[Docket No. 99-SW-80-AD]

Airworthiness Directives; Bell Helicopter Textron Canada Model 206L, L-1, L-3 and L-4 Helicopters

ACTION: Supplemental notice of proposed rulemaking; reopening of comment period.

Figure 1

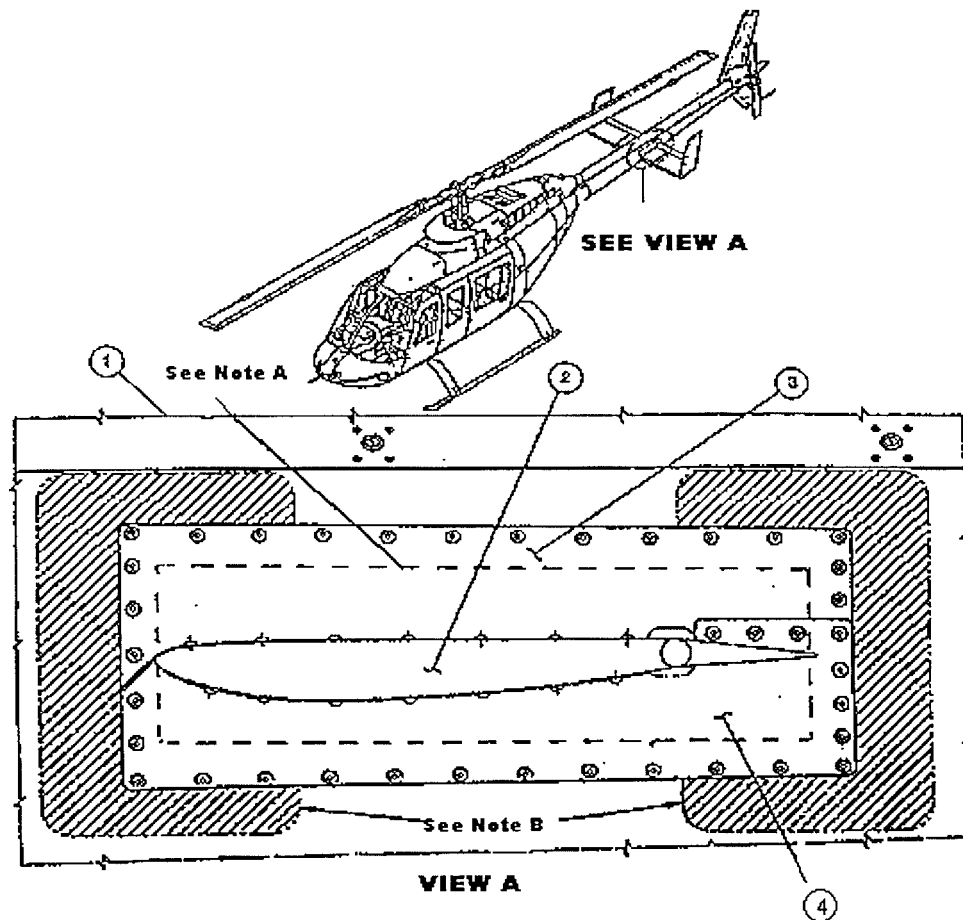
(a) Before further flight and thereafter at intervals not to exceed 10 hours time-in-service (TIS) until accomplishing a one-time fluorescent-penetrant inspection (FPI) required by paragraph (c)(2) of this AD, visually inspect for a crack in the tailboom using a 10-power or higher magnifying glass in the shaded areas as depicted in Figure 1 of this AD:

(b) At intervals not to exceed 5 hours TIS, visually check for a crack in the tailboom in the shaded areas as depicted in Figure 1 of this AD. The visual check may be performed by an owner/operator (pilot) holding at least a private pilot certificate and must be entered into the helicopter records showing compliance with this paragraph in accordance with 14 CFR 43.11 and 91.417(a)(2)(v).

(2) Perform a one-time FPI of the edges of the tailboom skins for any crack around the left and right horizontal stabilizer openings as shown in Figure 1 of this AD. Remove paint and primer to inspect the edges and exterior skin surface in the skin area at least 3/4 inch around the edges of the horizontal stabilizer openings as shown in Figure 1 of this AD.
